Docket No. 50-0219-LR

**PRE-FILED DIRECT TESTIMONY OF DR. RUDOLF H. HAUSLER**

**INITIAL PREFILED WRITTEN TESTIMONY OF  
DR. RUDOLF H. HAUSLER  
REGARDING  
CITIZENS' DRYWELL CONTENTION**

Figure 2

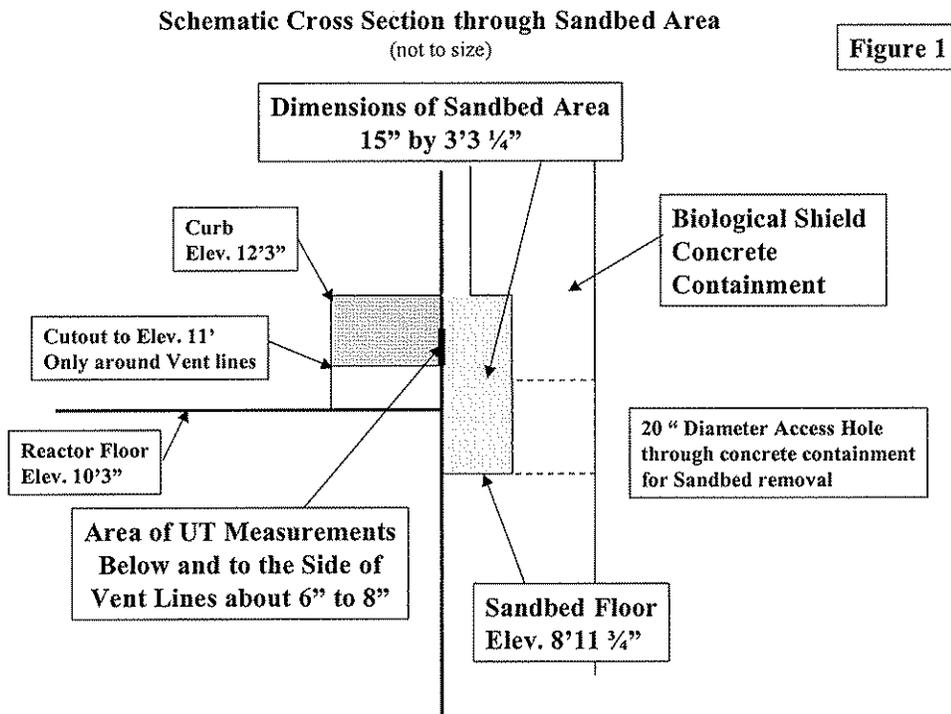
We take issue with this statement. In support of this contention, an effort was made to show graphically the remaining wall thickness observed in all of these various locations. Thus Figure 2 shows, by way of example, the remaining wall thickness from the 2006 UT measurements made with the help of 6 by 6 inch grids as a function of elevation in the **trench of Bay 17**. It is understood, as is described in Ref. 3 that 6 such grids were placed one on top of the other in the trench in order to capture the corrosion from the bottom to the top of the sandbed. Hence, if the bottom of the trench had the elevation about 9 feet, then the top of the 6 grids would have had an elevation of about 12 feet, which according to Figure 1 corresponds to the top of the sandbed and is at least 9 inches higher than the top of the grid used for UT measurements from the inside. (Note, none of these elevations is terribly accurate, however, the top of the trench measurements were definitely lower (deeper pits) by a good margin than the inside grid measurements). Figure 2 plots all individual 2006 measurements from the trench in bay 17. The 6 traces represent the variation of the wall thickness in the horizontal direction while the traces themselves extend from the bottom of the trench (left hand side) to the top of the trench (right hand side). The

Figure 2, attached to Ex. 12, plots all individual 2006 measurements from the trench in Bay 17. The 6 traces represent the variation of the wall thickness in the horizontal direction while the traces themselves extend from the bottom of the trench (left hand side) to the top of the trench (right hand side). The undulations of the 6 traces, which are at times (at the same elevation) in synch and at other times out of phase show the nature of the “golf ball type” surface described in AmerGen literature. Where the undulations are in synch, the pit at that location extends over an area larger than just one inch in diameter. The average amplitude of the undulations in Figure 2 are of the order of 0.1 inch.

Figure 2 further shows that the corrosion is most severe at the top, almost uniform in severity over most of the depth of the sandbed and again somewhat more severe at the very bottom. To shed light on these issues, Figure 4, also attached to Ex. 12, compares the average remaining wall thickness from trench measurements (averaged over the horizontal direction) with the average of the 6 by 6 grid measurement from the inside and the direct UT measurements from the outside. Also graphed in this figure are the averages of the external measurements for the three zones for which data are reported.<sup>2</sup> The averages for the grid and the trench data overlap quite well at the same elevation, but the floor and above curb zones are significantly thinner than the curb zone in which the grids are located. Figure 4 actually shows that the external data better represent the floor and above curb zones.

Figure 3

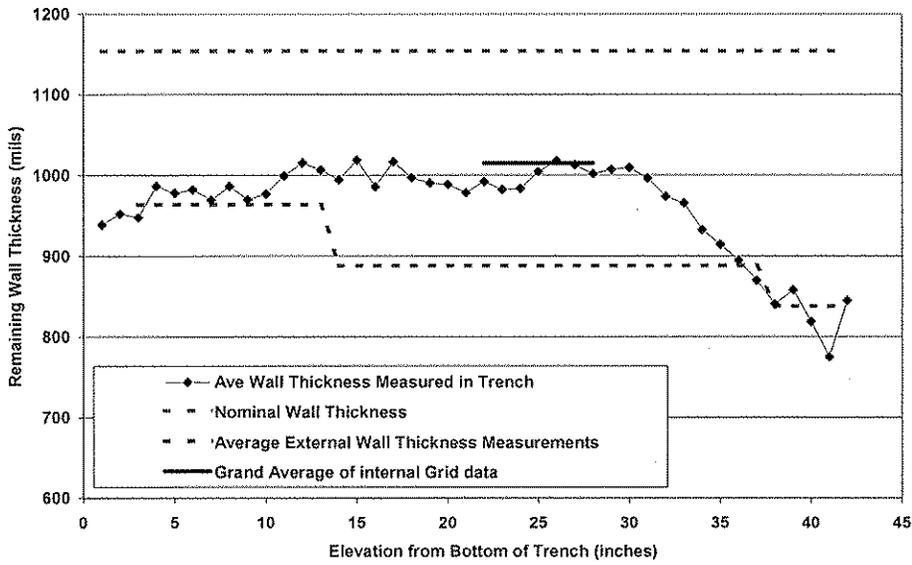
In Figure 3 an effort is being made to compare the average remaining wall thickness from trench measurements (averaged over the horizontal direction) with the average of the 6 by 6 grid measurement from the inside and the direct UT measurements from the outside. Also graphed in this figure are the averages of the outside measurements for the three zones for which data are reported (Ref. 5). What one can see is that the averages for the grid and the trench data overlap quite well at the same elevation. However, the average outside measurements are significantly lower at comparable elevations. <sup>4)</sup> This is probably because the choice of location for the external measurements was deliberately biased towards thin spots.

Figure 4

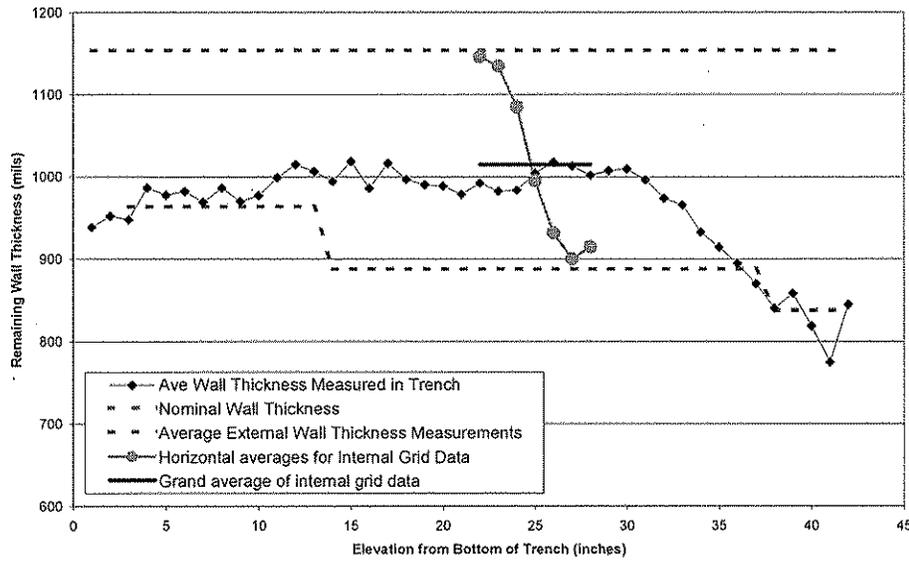
Finally in Figure 4 we see the spread of the 6 by 6 inch inside grid measurements superimposed on the averages of the other measurements.

AmerGen has argued that applying uncertainty to these results is unnecessary because they are already biased toward the thin side. However, this qualitative reasoning is undercut by Ex. 4, Figure 4, which compares all the data available for Bay 17. It shows that while the external data are indeed biased low for the middle elevations, they overestimate the mean thickness compared to the trench data for the most extreme upper and lower elevations. Thus, it is necessary to take account of the uncertainty in the external data to derive statistical estimates of parameters of interest, such as the mean thickness of the shell in the sandbed region.

Figure 5

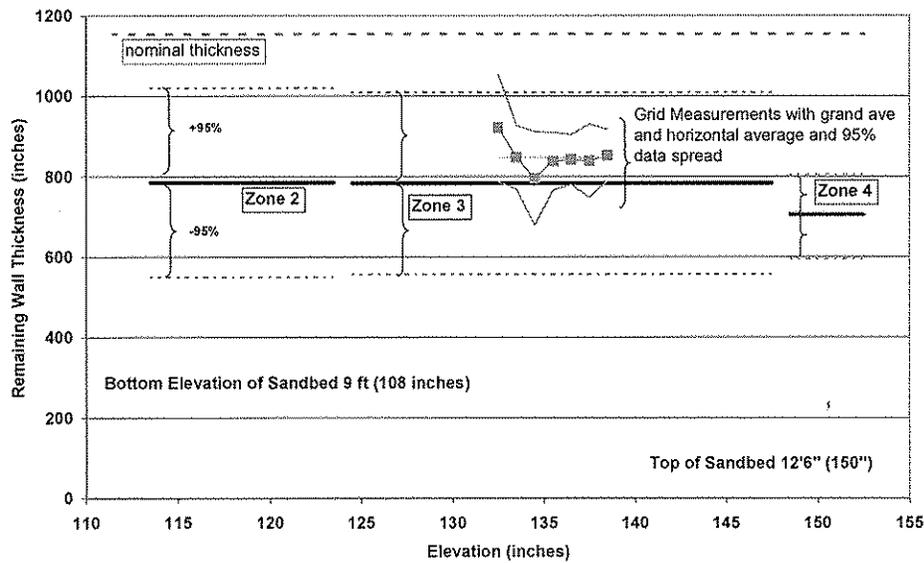
Figure 5 shows an analysis of the available 2006 data for Bay 13. Bay 13 is probably the second worst corroded bay apart from Bay 1. The averages for the external measurements for each zone are fairly similar, as are the 95% limits for the data spread. There is a 95% percent probability for the deepest penetration to be of the order of 48% of the original wall thickness. The superposition of the internal grid data shows a higher average and a narrower distribution of the data spread. Again one recognizes that the internal 6 by 6 inch grid measurements do not represent the worst corrosion degradation.

Bay 19 External 2006 UT Measurements, Minimum Values

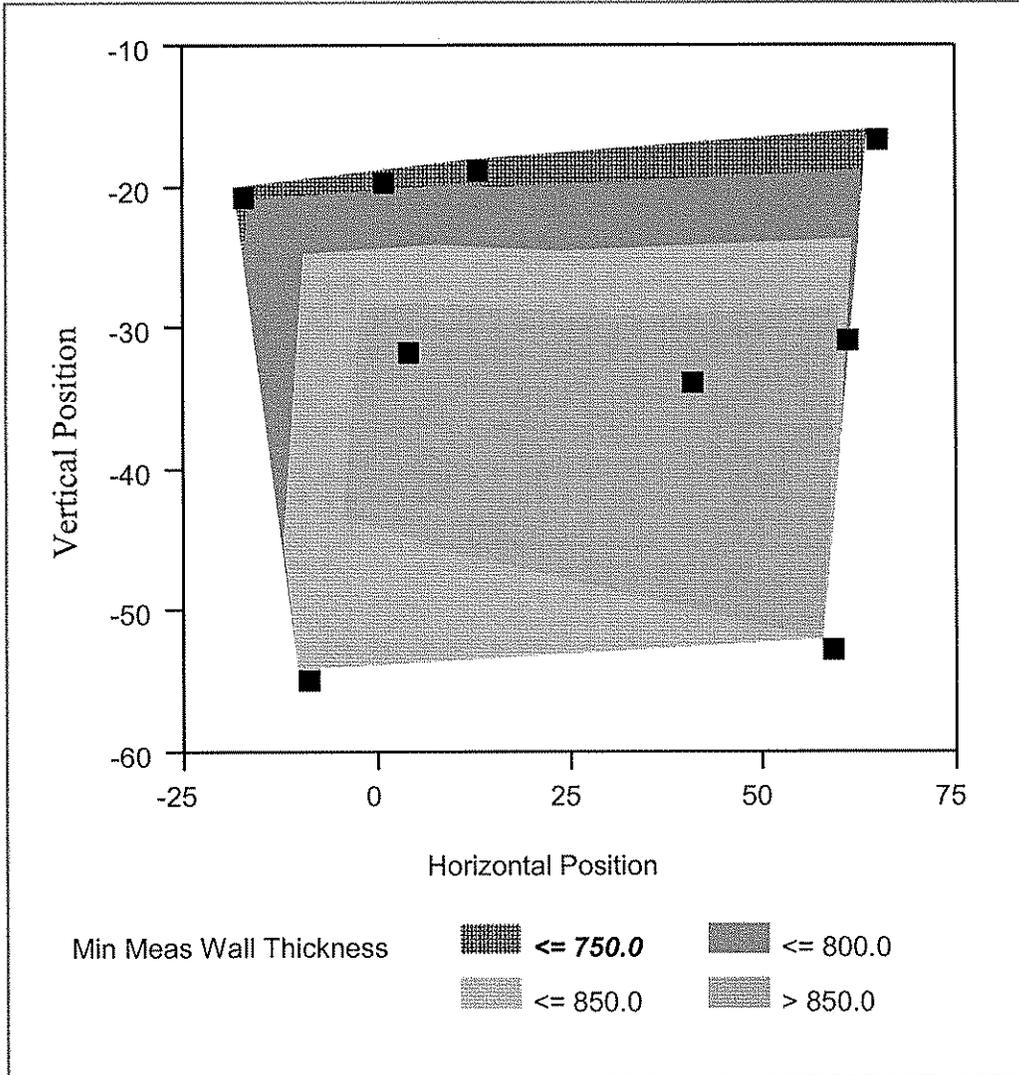
The advantage of this evaluation is that one can see all the available data in a quantitative presentation. Thus, one can see in Figure 1 that an area exists at elevation -20 (20 inches below the reference point) where the remaining wall thickness is less than 750 mils, or less than the criteria for general thinning at 95% confidence. This area extends from 20 inches on the left (-20 inches) to about 60 inches on the right (+60 inches), or about 7 feet. The width of this area in Fig. 1 is maybe 4 to 5 inches, however, because measurements were not extended toward lesser elevations (from the reference point) one simply cannot estimate how much further the serious the corrosion may extend in Bay 19.

**Figure 1** mentioned previously shows a heavily corroded area in Bay 19 at elevation -20. The extent of this area is highly uncertain because it was not further defined by additional UT measurements toward higher elevations (>-20). Indeed, one could find here an extended bathtub ring area.

Finally, Bay 19 has an elongated area that is thinner than 0.736 inches, but is very poorly defined spatially. Calculation C-1302-187-5320-024, Rev. 2, Ex. 33 (AmerGen Ex. 16) at 95; Ex. 13 at Figure 1. The extent of this area could range from around 3 square feet to more than 9 square feet.

**Figure 2**  
**Bay 1 Remaining Wall thickness**  
**External UT Measurements 1992/1993**

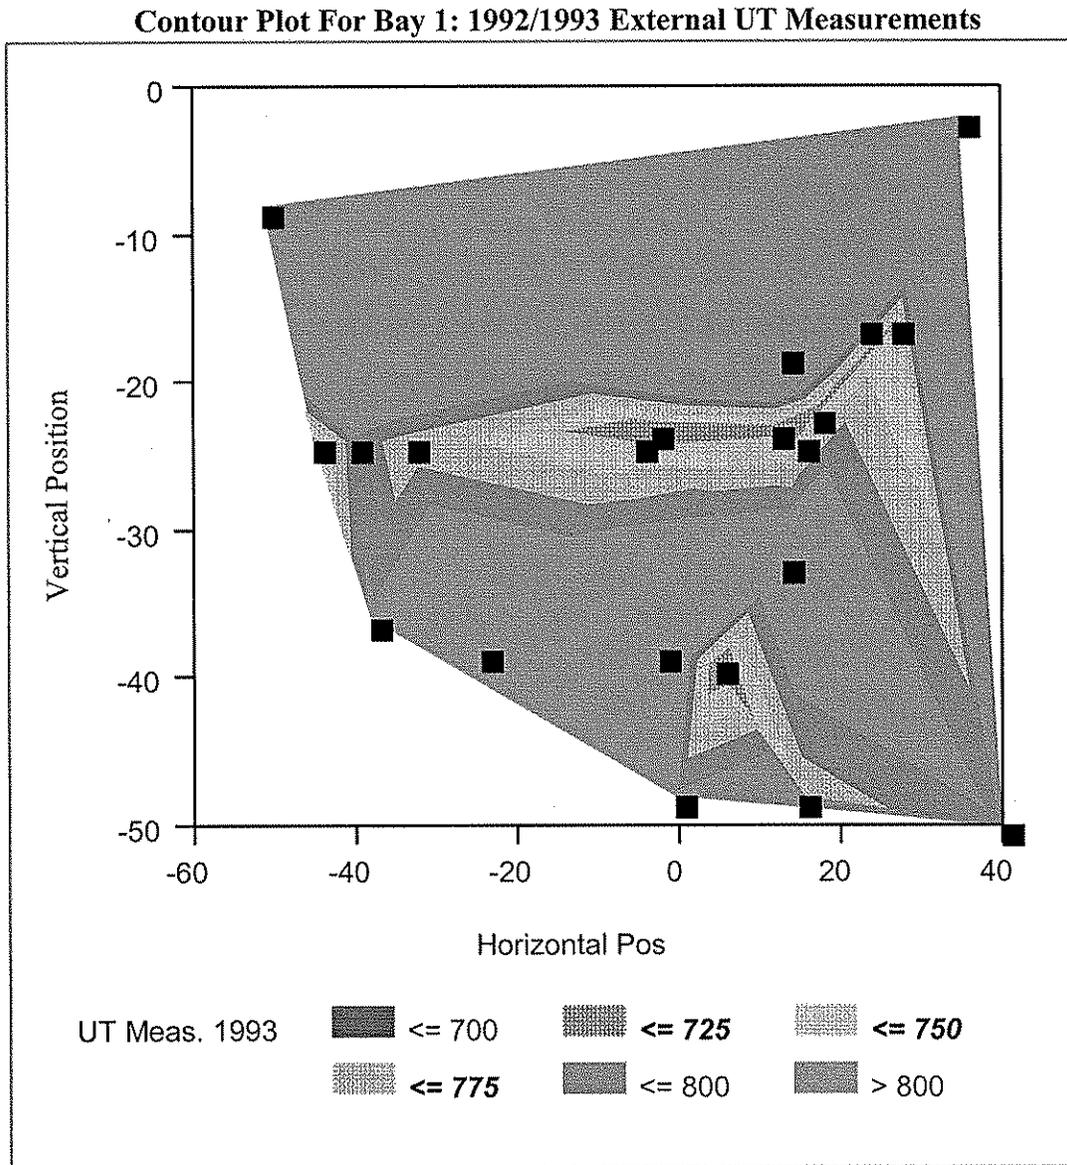
The data used for the analysis are contained in Tables 1 and 2 for Bays 1 and 13 as extracted from AmerGen documents. Presumably, these were the most corroded Bays. Figure 2 shows a contour plot for Bay 1 obtained with the data from 1992. The dimensions of the points in the plot are 2.5 by 2.5 inches. Again, one needs to remember that the specific shape of the contours depends not only on the residual wall thickness measured at the locations indicated, but on the density of measurements as well. (For instance, an additional measurement at coordinates h (-20) v (-25) could completely alter the contours and in all likelihood extend the area of wall thickness below -750 mils <sup>4)</sup>.

Nevertheless, it appears in Figure 2 that in the so called “bathtub ring” an extensive area exists with wall thicknesses between 700 and 750 mils (0.75 inches). This area extends well over 52 inches (4<sup>+</sup> feet) and is about 5 inches wide. In view of the fact that UT measurements are at best accurate with a standard deviation of about 45 mils, (95% confidence limits +/-90 mils), this area could well be more extensive.

Bay 1 Remaining Wall thickness  
External UT Measurements 2006

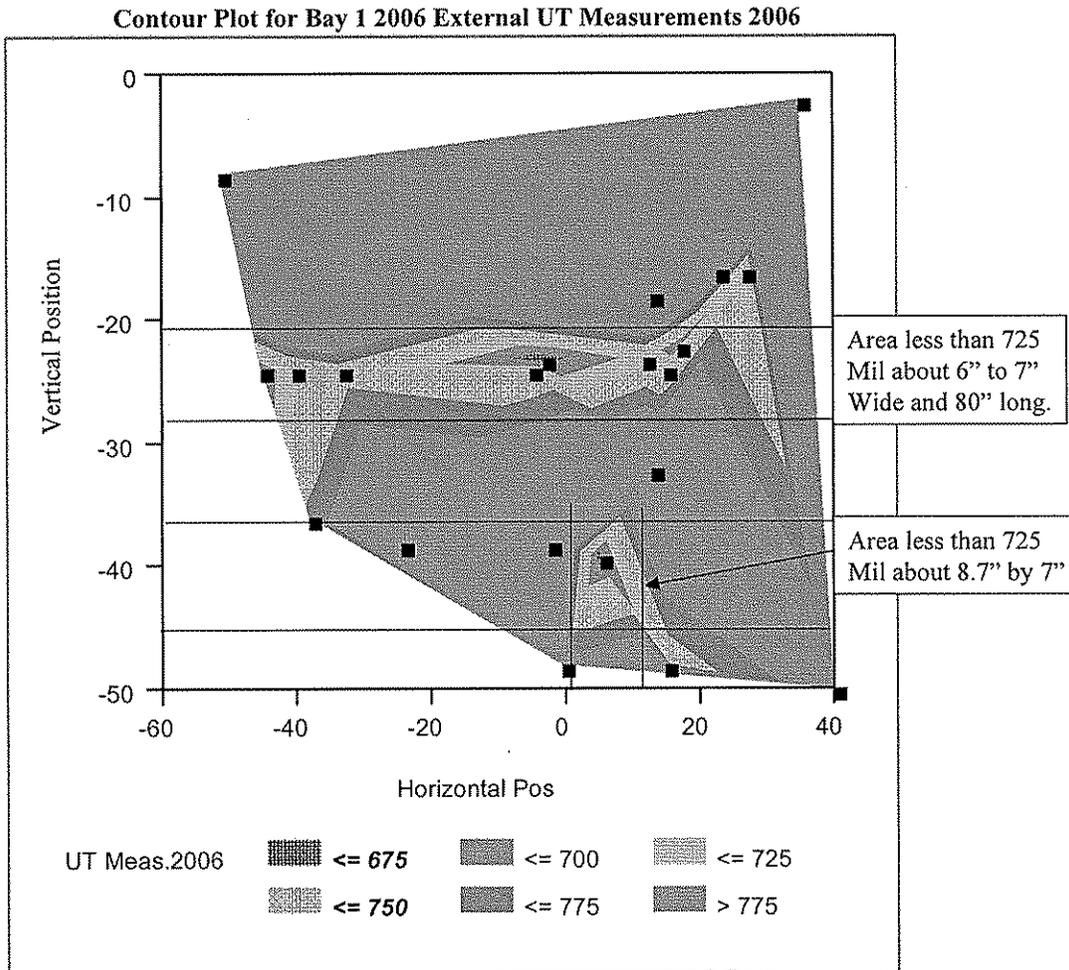
**Figure 3** shows the contours for Bay 1 obtained with the data from the 2006 inspection. The general shapes are the same as in Figure 2 except that here we have sizeable areas with residual wall thicknesses below 725 mils. The unexpected thing is

Based on Figure 3, together with an assessment of the accuracy (reliability) of the data one must conclude that there is a good likelihood that the entire bathtub ring area extending from 40 to -40 inches on the horizontal axis and from about -30 to perhaps -20 inches on the vertical axis is below the 0.736 inch criteria for general thinning and is, much larger than the one square foot acceptance criterion. (Of course, since this area is the most corroded, it will taper off to higher wall thickness on both sides of the vertical axis). The corroded area is indeed shaped quite irregular, but one could venture a guess that the contoured areas below 750 mils are of the order of 4 to 7 square feet all together. This estimated area does not include the area to the left of -40, which probably contains additional area below 0.750 inches.

**Bay 13 Remaining Wall Thickness**  
External UT Measurements 1992/1993

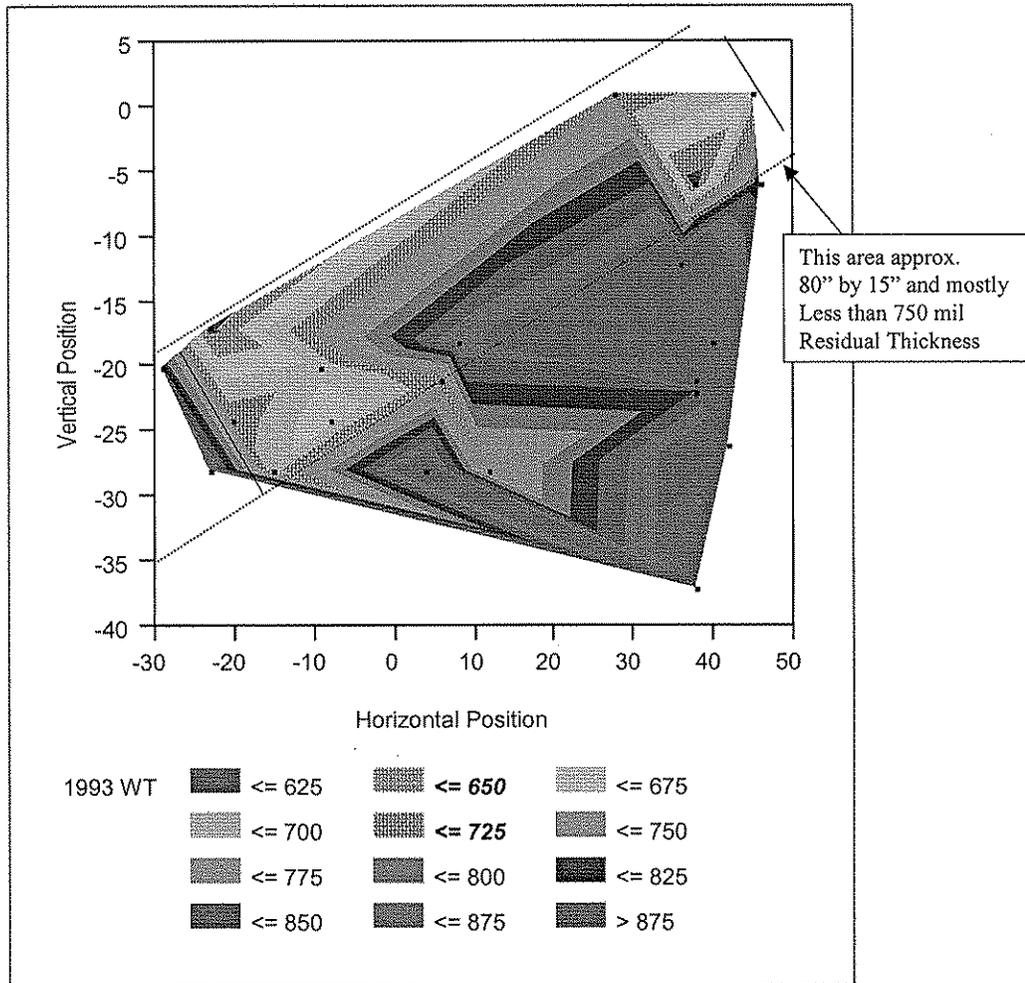
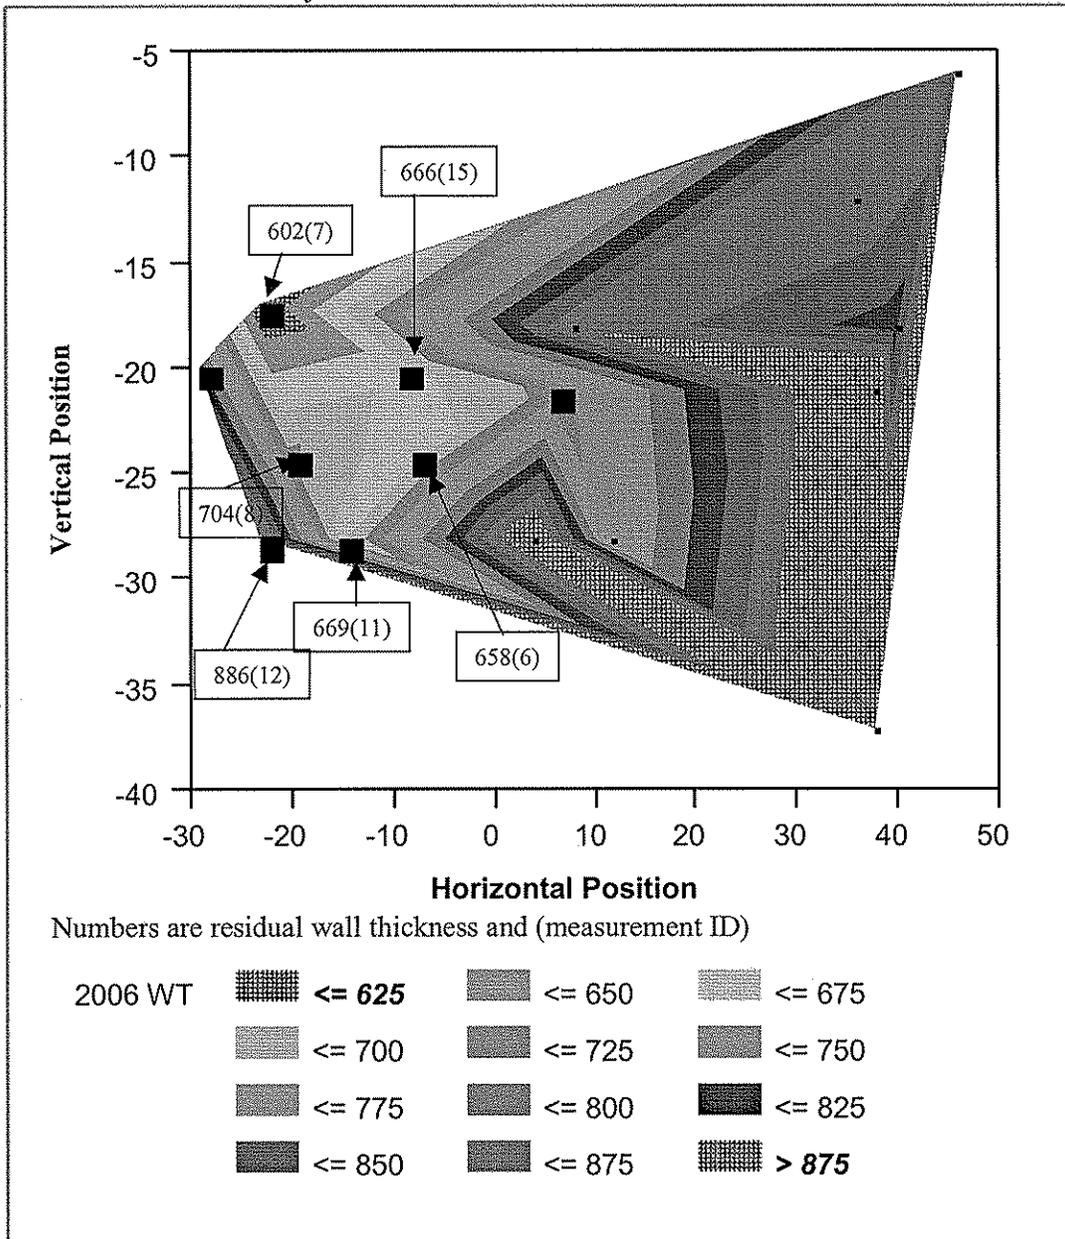
**Figures 4 and 5** show the contours for Bay 13, 1992 and 2006 data, respectively. Here large areas exist with wall thicknesses below 700 mils and at least two seemingly unconnected areas where the residual wall thickness is less than 650 mils. It could be argued that those heavily corroded areas are less than 1 square foot and therefore are still acceptable according to the 636 mil criterion. However, the heavily corroded area on the left hand side (-20, -20) has not been further explored. One therefore does not know whether it might extend further. Similarly, the area on the right ((40, -7), clearly showing a fairly deep pit, was not further explored and was not even measured in 2006. While in Bay 1 the bathtub ring was at elevation -20 to -25 (from the reference point) in Bay 13 there is no clearly prominent bathtub ring. This may be because it was not there, but it may also be because the measurements were not extended toward elevation -15 and -10. We are therefore left with a great uncertainty as to the true extension of the damage in this Bay.
